ATTACHMENT 2

PROPOSED CHANGE TO  
TECHNICAL SPECIFICATION  
SURVEILLANCE 4.4.6.2.2d

ATTACHMENT 2  
 ST-HL-AE-3673  
 PAGE 2 OF 2

# TRAIN C CHECK VALVE LEAKAGE DETECTION SYSTEM

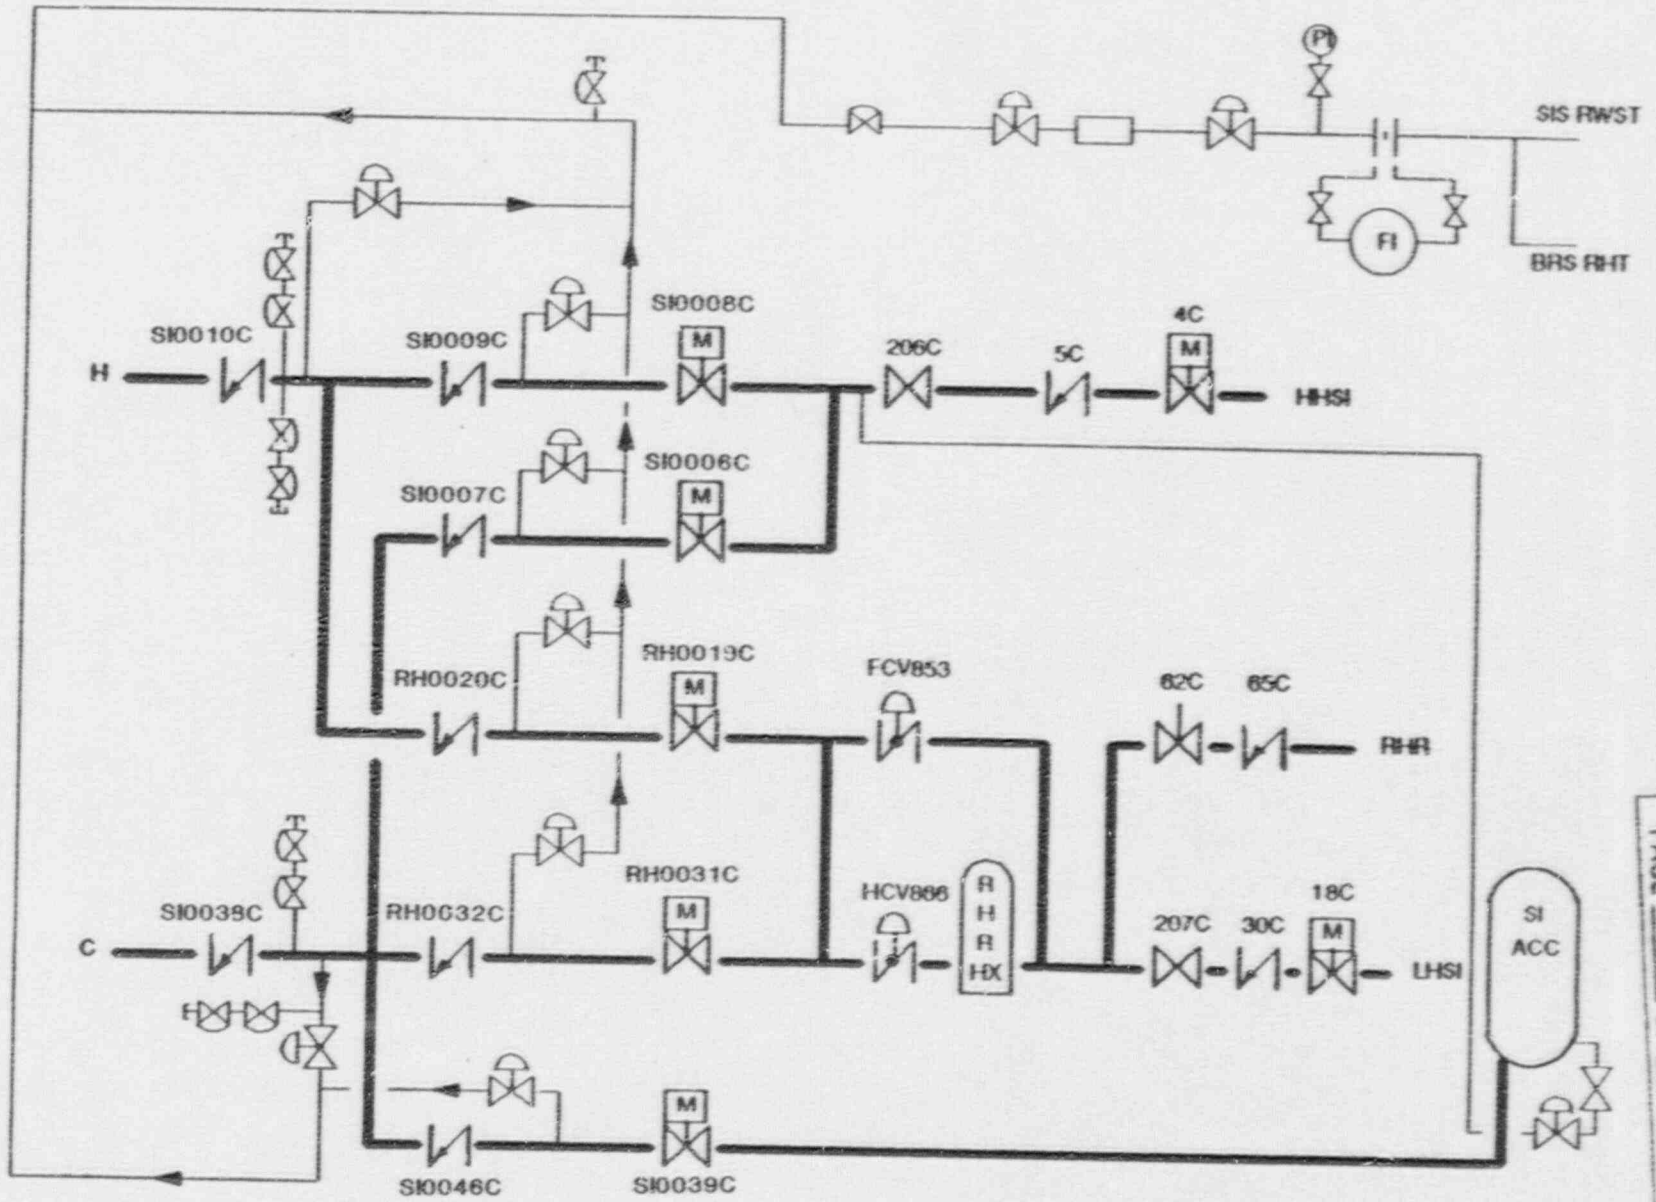
4.4.6.2.2 Each Reactor Coolant System Pressure Isolation Valve specified in Table 3.4-1 shall be demonstrated OPERABLE by verifying leakage to be within its limit:

- a. At least once per 18 months,
- b. Prior to entering MODE 2 whenever the plant has been in COLD SHUTDOWN for 72 hours or more and if leakage testing has not been performed in the previous 9 months,
- c. Prior to returning the valve to service following maintenance, repair or replacement work on the valve, and  
*Prior to entering MODE 2*
- d. ~~Within 24 hours~~ following valve actuation due to automatic or manual action or flow through the valve except for valves XRH0060 A,B,C and XRH0061 A,B,C.
- e. As outlined in the ASME Code, Section XI, paragraph IWV-3427(b).
